**TOWN OF OCEAN RIDGE  
PLANNING & ZONING REGULAR MEETING  
AGENDA**

**January 20, 2026 at 9:00 AM  
Town Hall - Meeting Chambers**

| <b>Subject:</b>      | <b>62 Harbour Dr North – Development Plan Review</b> |

**PLAN REVIEW REPORT**  
**62 Harbour Drive N**  
**11/21/25 12/04/2025**

PRIVATE RESIDENCE  
62 HARBOUR DRIVE NORTH  
OCEAN RIDGE, FLORIDA

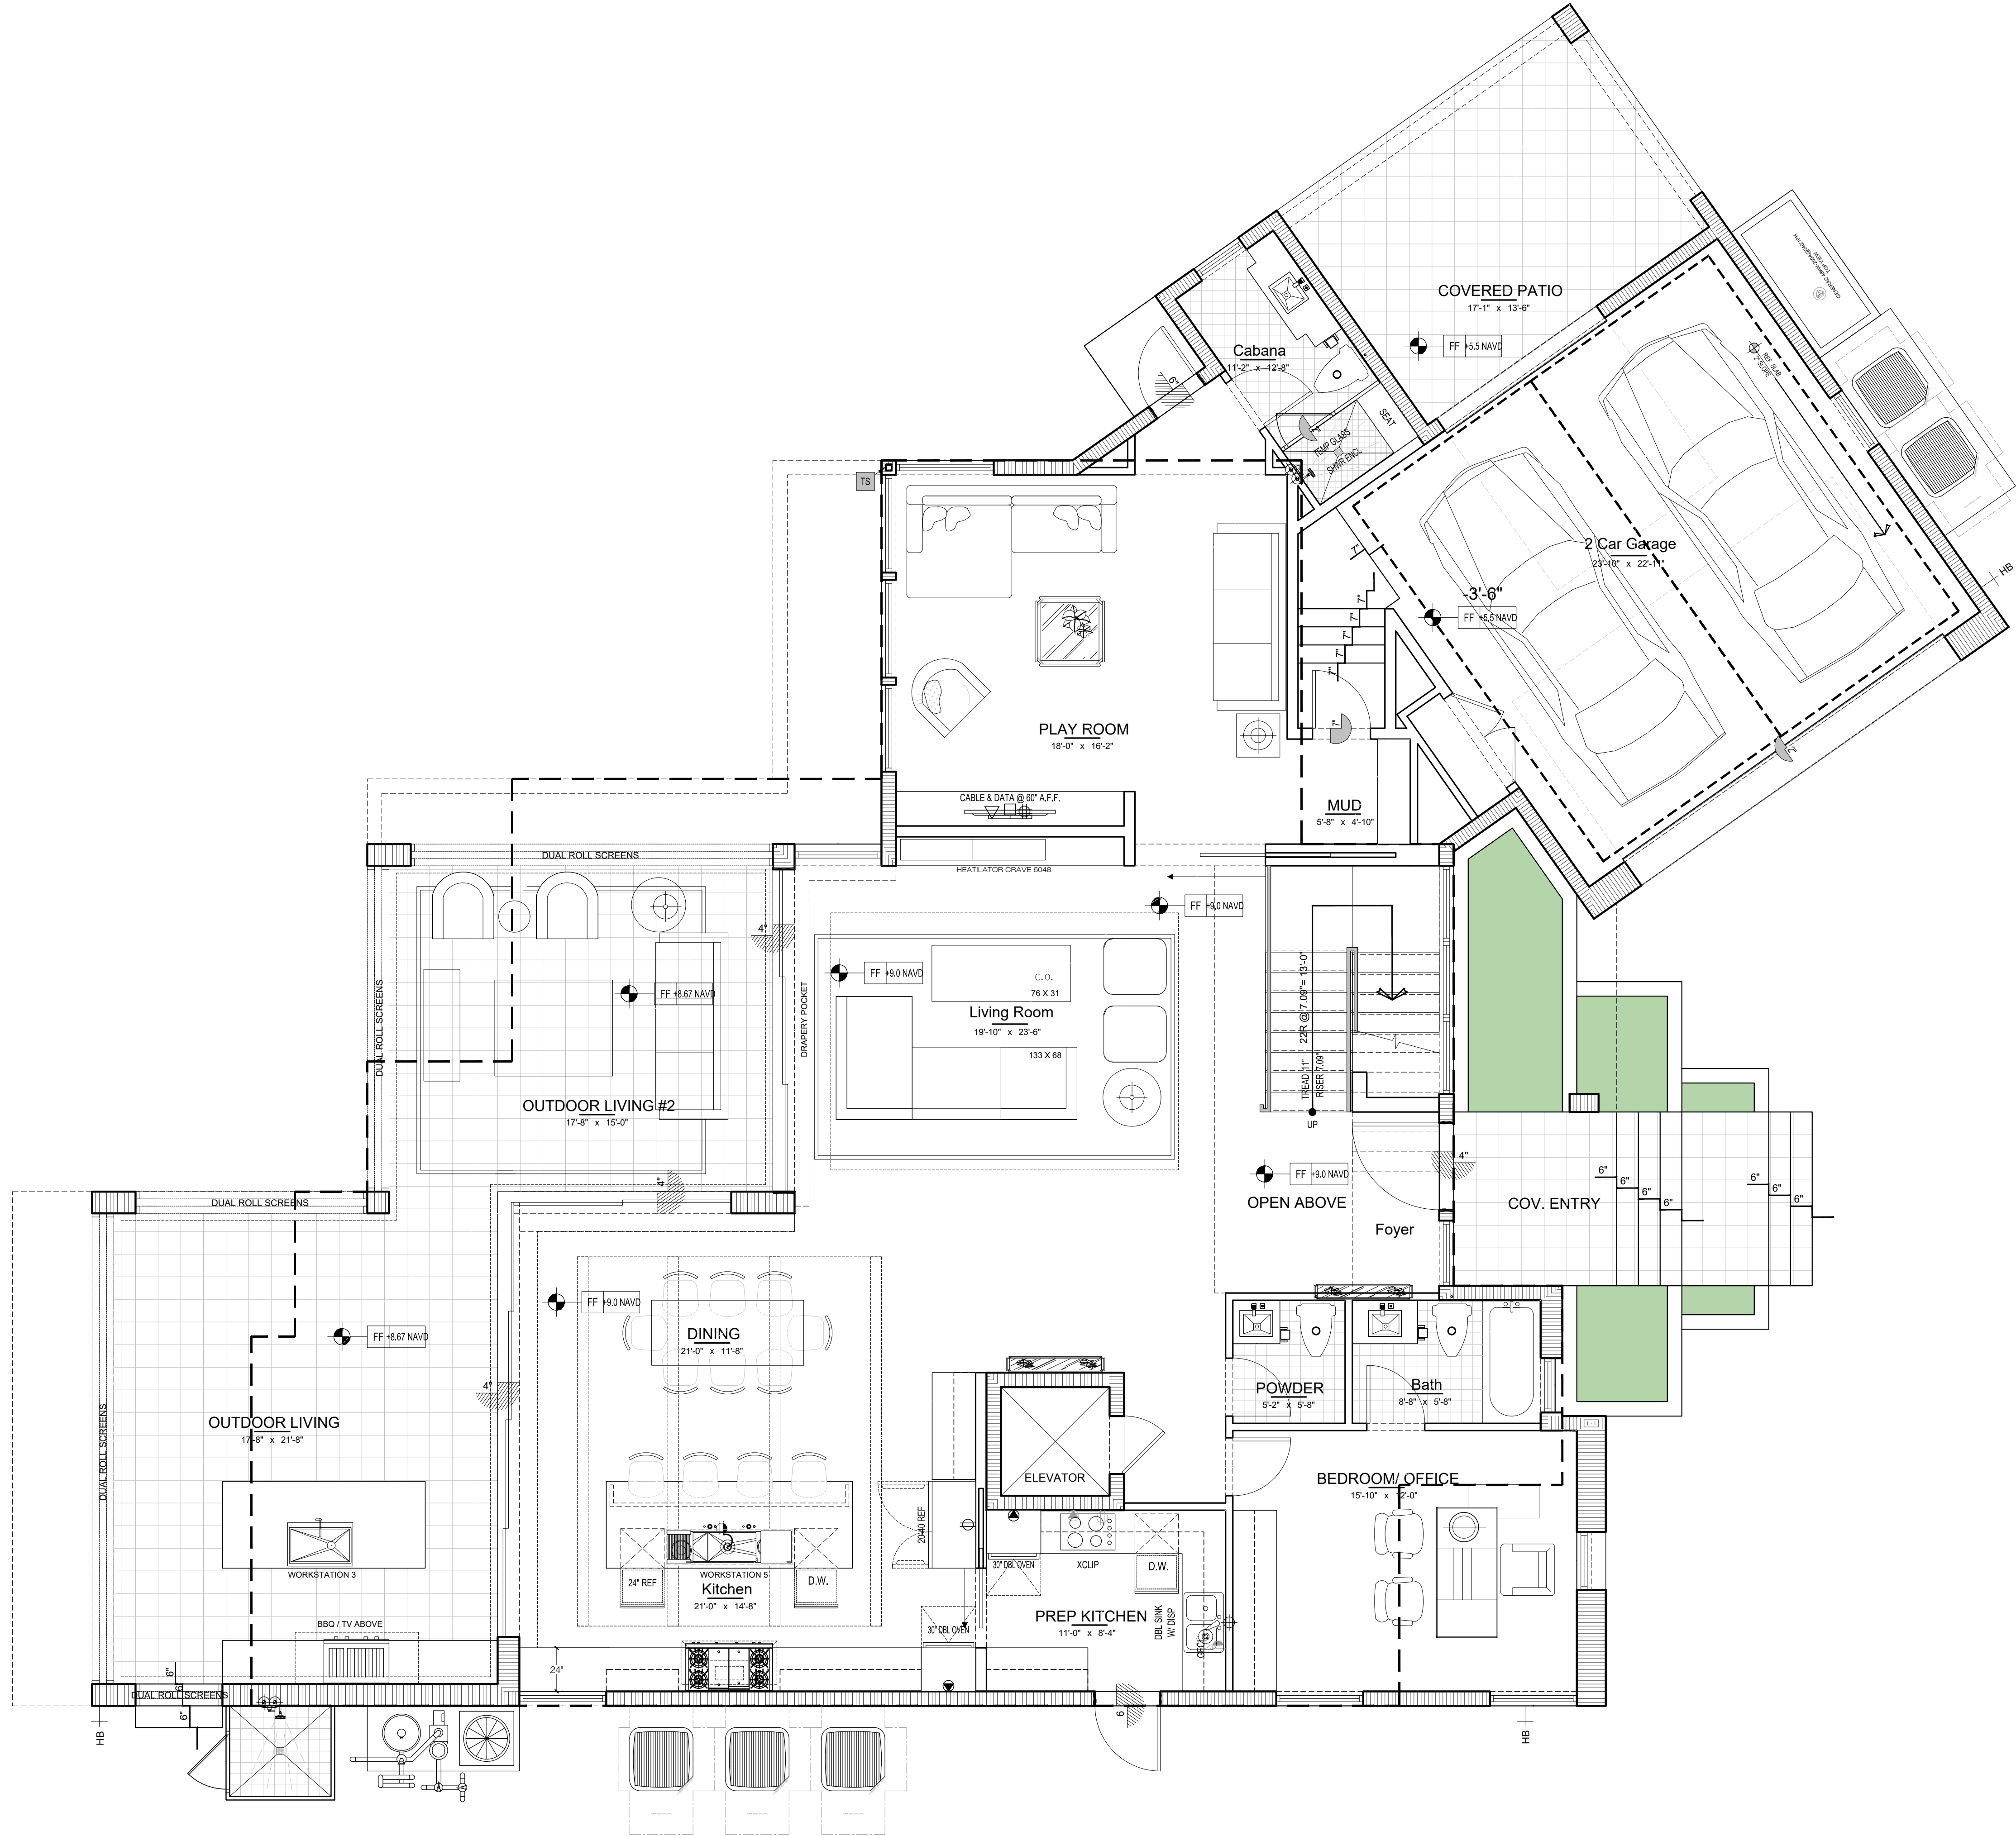
**Comment:** Please provide a written explanation of why the proposed 3' 3" setback is necessary. **The written explanation is that the hardscape follows the 2022 plans which does not provide any justification for the proposed driveway setback. Condition of approval that the applicant provide justification for the Planning and Zoning Board meeting.**

**Comment:** Please revise site plan Sheet A100 to delete all improvements that are prohibited in this setback area. **The written explanation is that the hardscape follows the 2022 plans which does not comply with the Town Code. The Town Code prohibits these improvements and a condition of approval is that the plans are revised to comply with the code for the Planning and Zoning Board meeting as they cannot be approved.**

**Background:** The maximum floor area of all finished floors under roof shall be 36 percent of the total lot area. The data tabulation on sheet A100 indicates that the proposed floor area is 41%, which exceeds the maximum allowed by the town code.

**Comment:** Although the Planning & Zoning Board recommended approval of an ordinance amendment providing incentives for the dedication of easements it has not been adopted at this time and if adopted, may not necessarily be adopted in its current form. As such this design cannot be approved at this time and should be revised to comply with the current code provisions. **Condition that approval is contingent upon adoption of ordinance amendment, and if not adopted the approval is void.**

**Answer:** see attached site plan with driveway shifted away from property line.

**Answer:** See revised site plan with stair to the south of the pool removed, and steps to the north of the pool to be nonstructural dry- stacked steps.

**Answer: Please defer to P&Z approval**

**Answer: See updated site plan A100**

**Answer: See updated site plan showing the new proposed seawall to be at 5.0'NAVD minimum.**

1 ROOF PLAN  
1/4" = 1'-0"

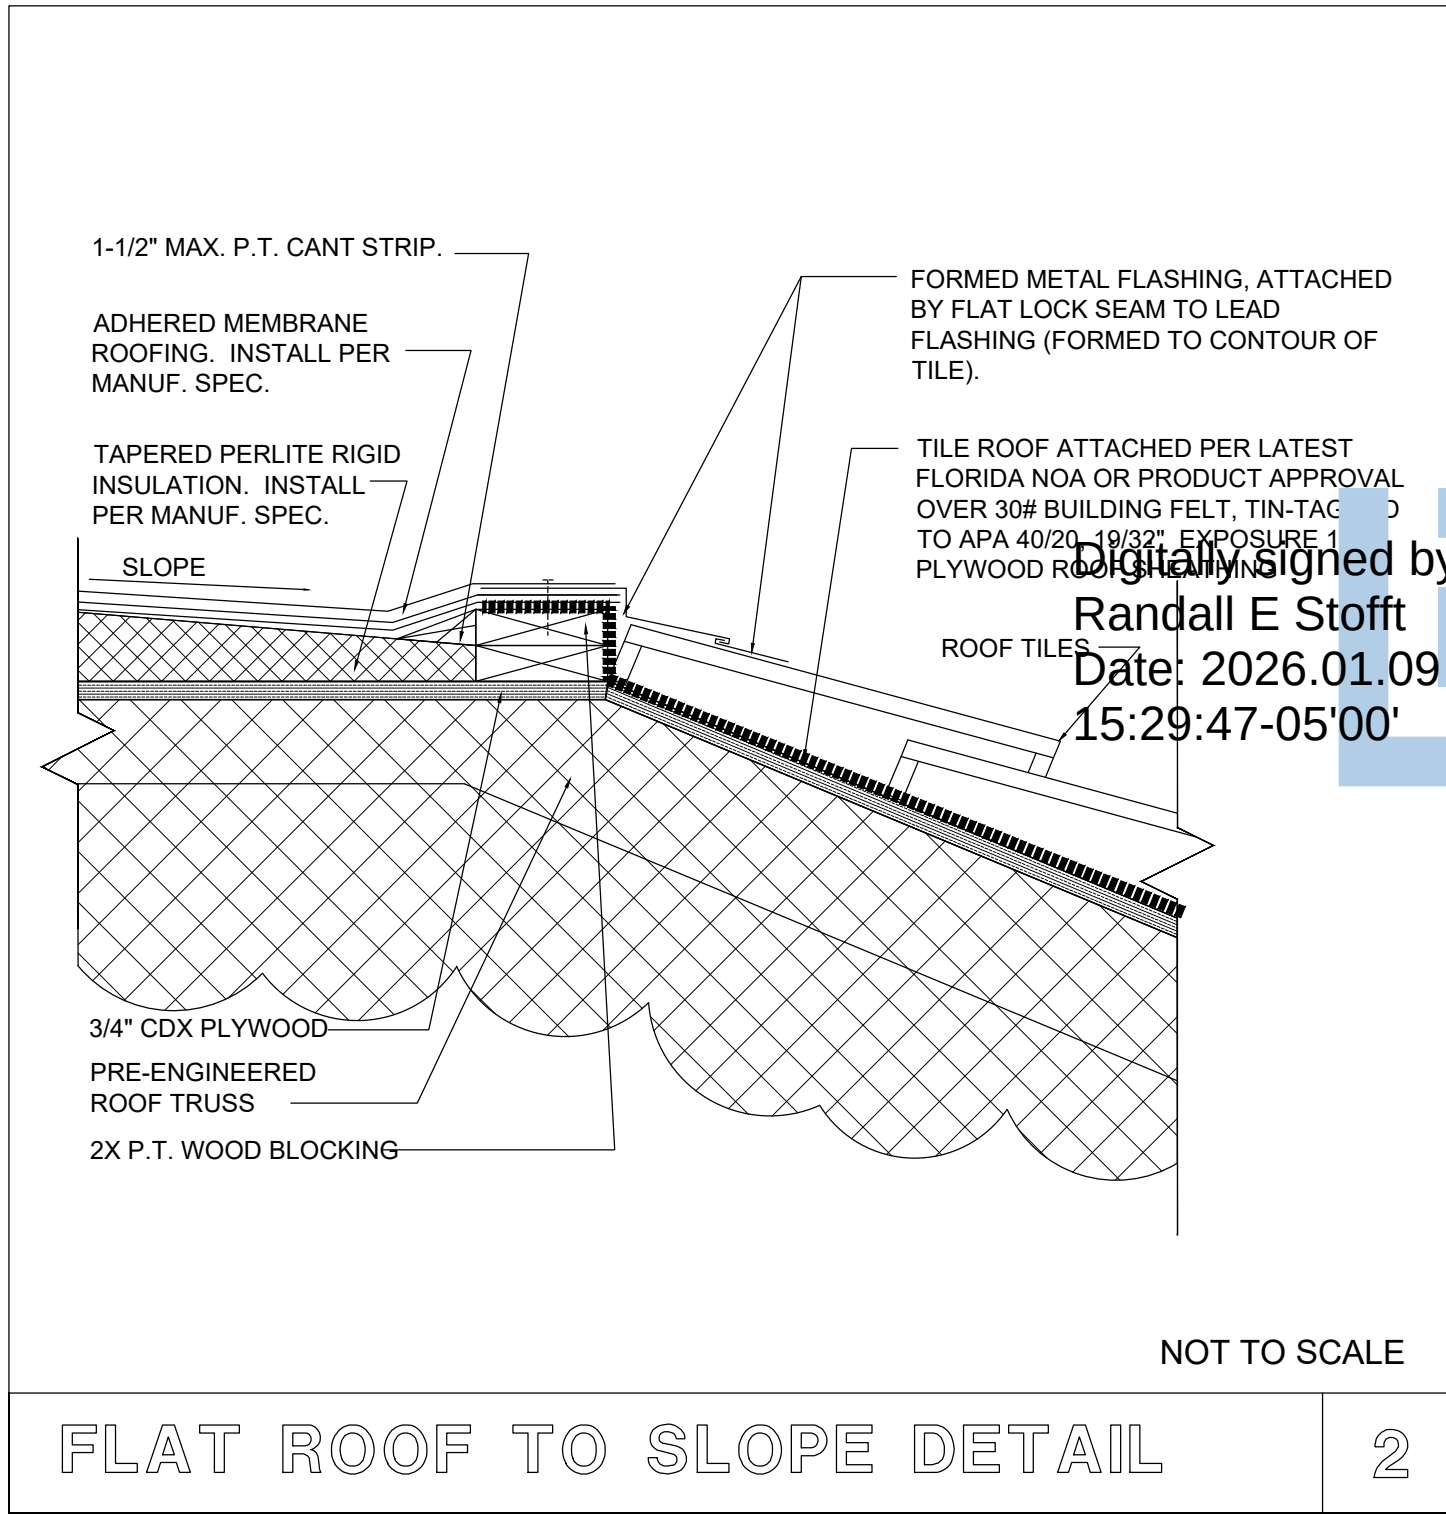
**Section 64-1(f)(1)**      **Background:** This code section requires a minimum roof pitch of 4:12 and a maximum of 14:12, but allows the planning and zoning commission to approve a pitched roof minimum of 3:12 as a special design exception subject to the development plan review criteria in section 63-56. The roof plan sheet A7 shows a roof pitch of 3.5:12 and 2.5:12.

~~Also, please remove the remnant images of the stairs and elevator on Sheet A7. Comment generally addressed. The revisions changed the proposed roof pitch from 2.5:12 to 3:12 and the written response to comments specifies that it is a special design exception.~~

SAID LANDS SITUATE IN PALM BEACH COUNTY, FLORIDA AND CONTAINING 11,733.21 SQ. FT./0.26694 ACRES, MORE OR LESS.

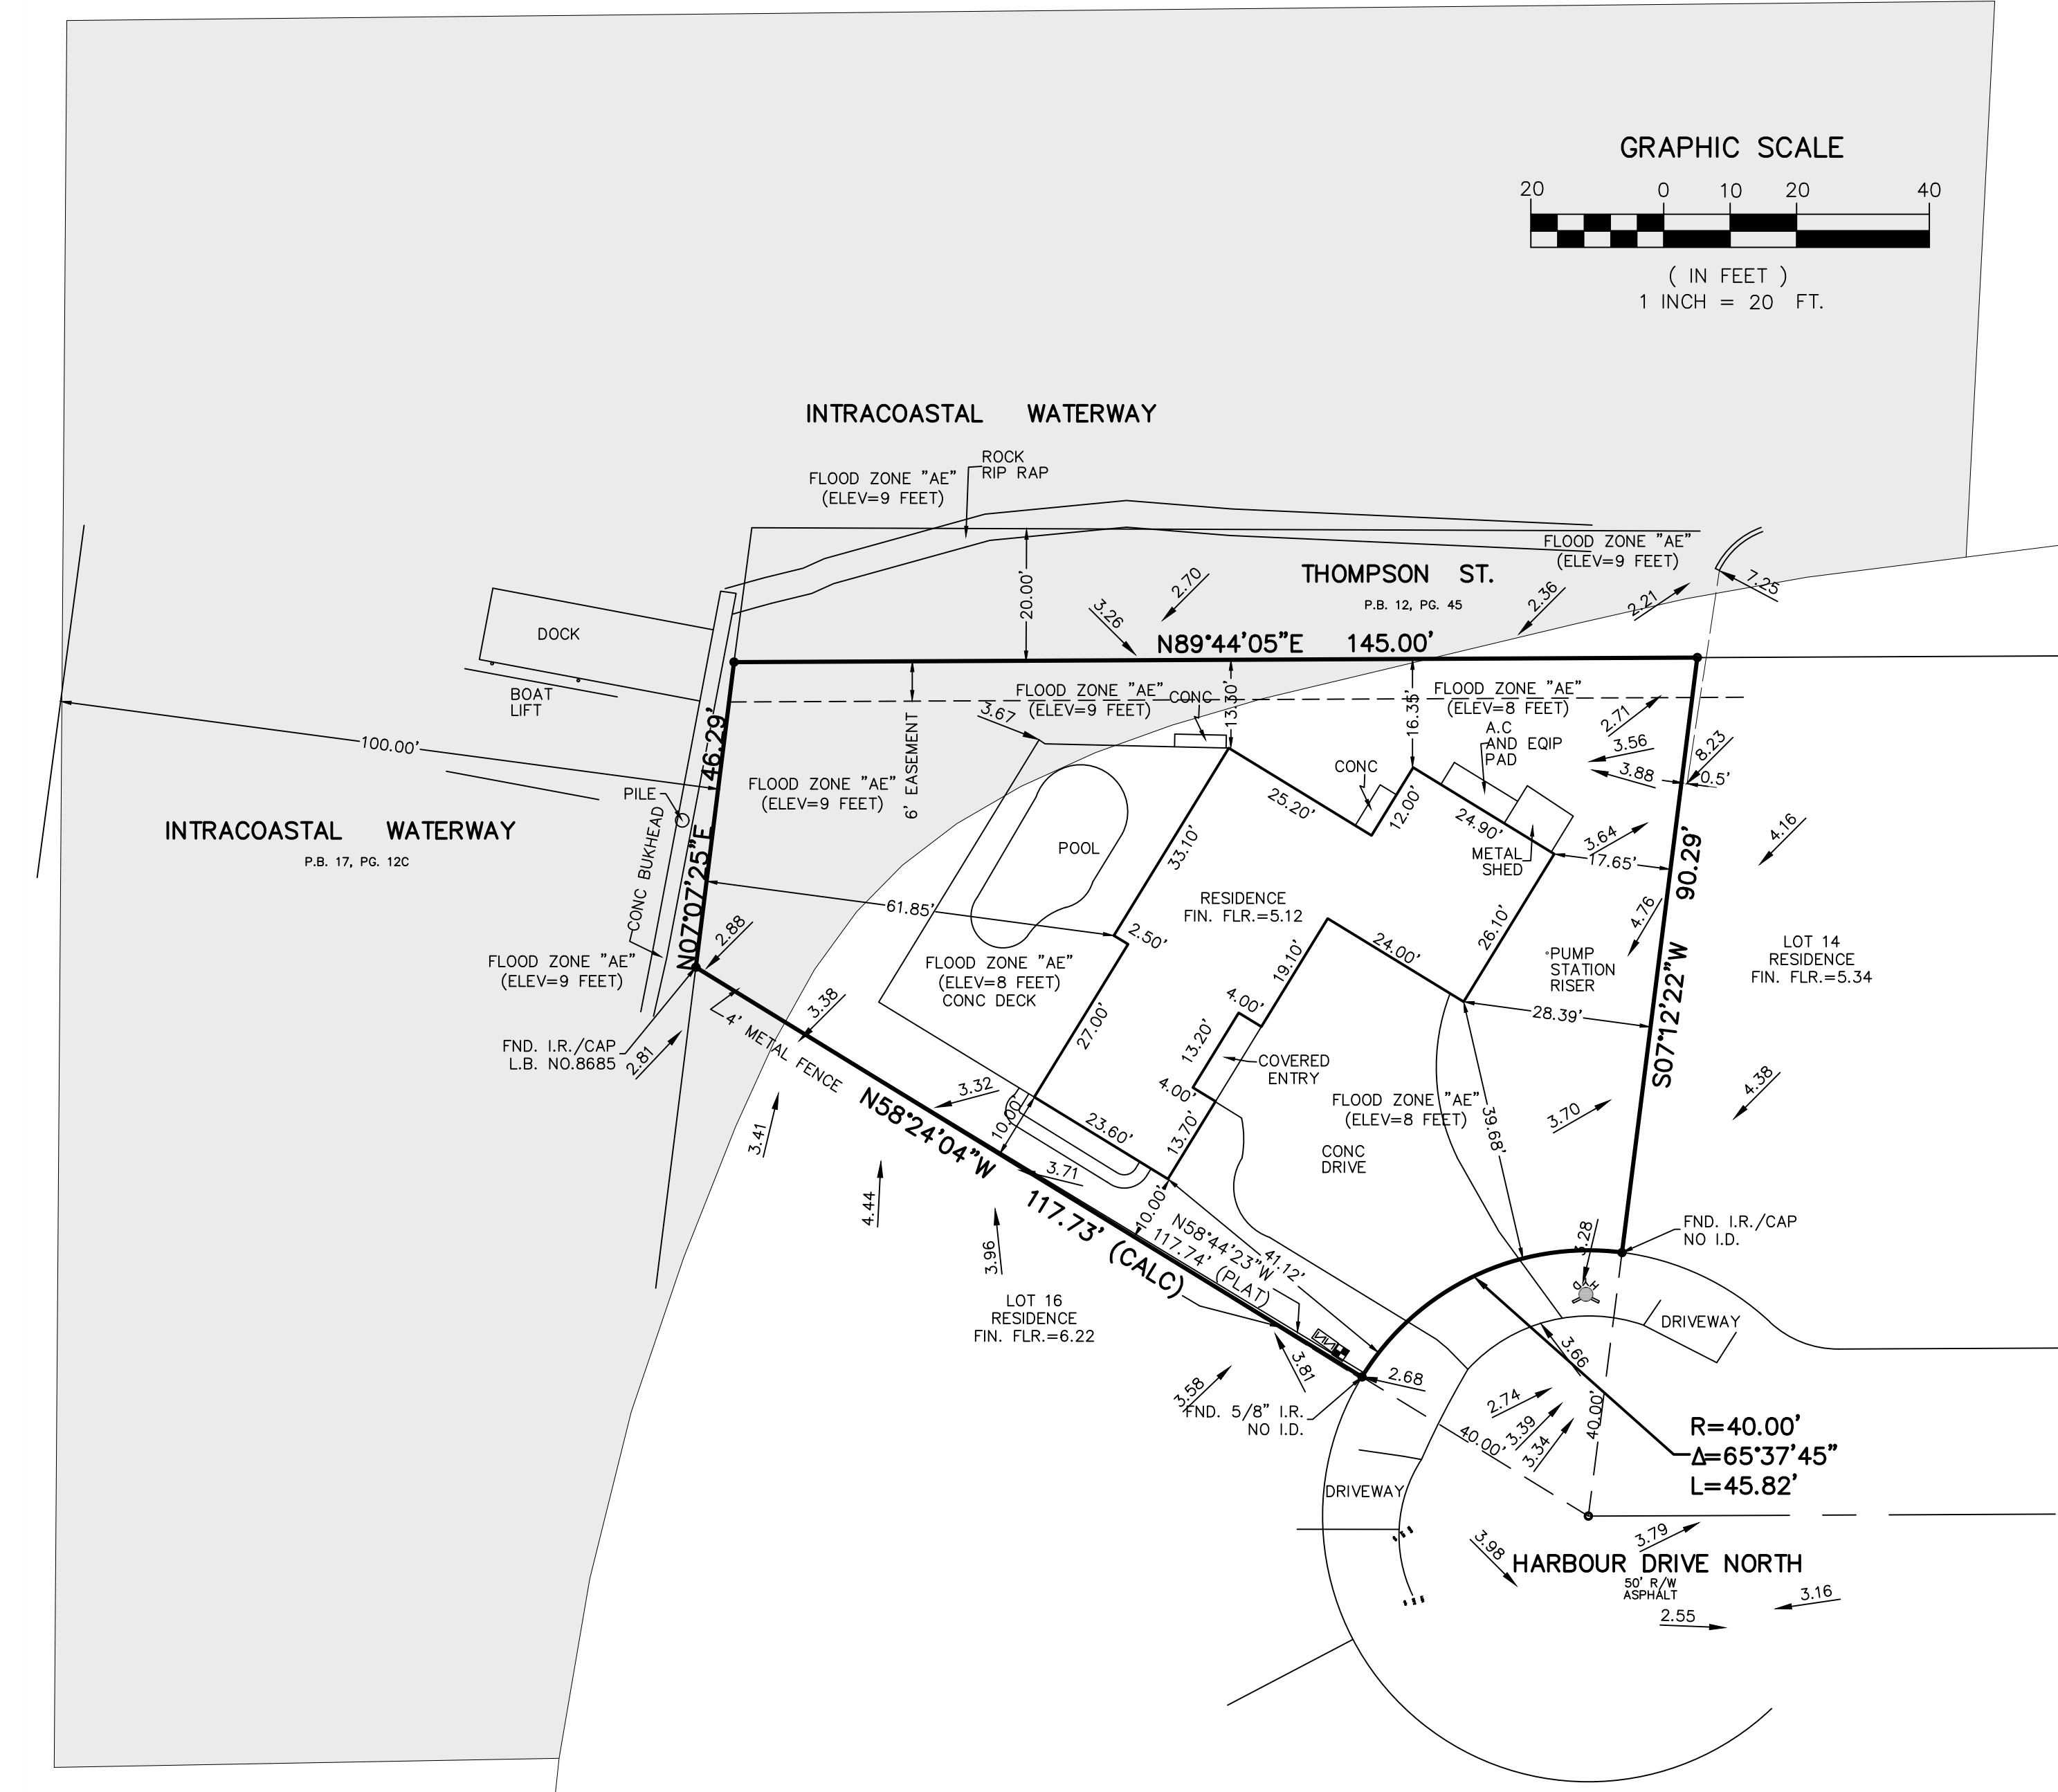
2. Based on the revised boundary survey, it appears the FEMA Flood Zone AE, BFE 9' is in the property limits. Provide an overlay of the flood zone on the proposed Site Plan to assure the building does not fall with the BFE 9.0 and therefore the FFE will need to be revised. Confirm the pool and other areas in the BFE 9.0 are not structurally attached to the building. See attached markup of the survey.

3. Provide boundary and topographic survey dated within one calendar year. Provide additional topo. grades along the north property line verify no impacts to the right-of-way. This may be completed after DPR approval.

**Answer: See updated survey.**
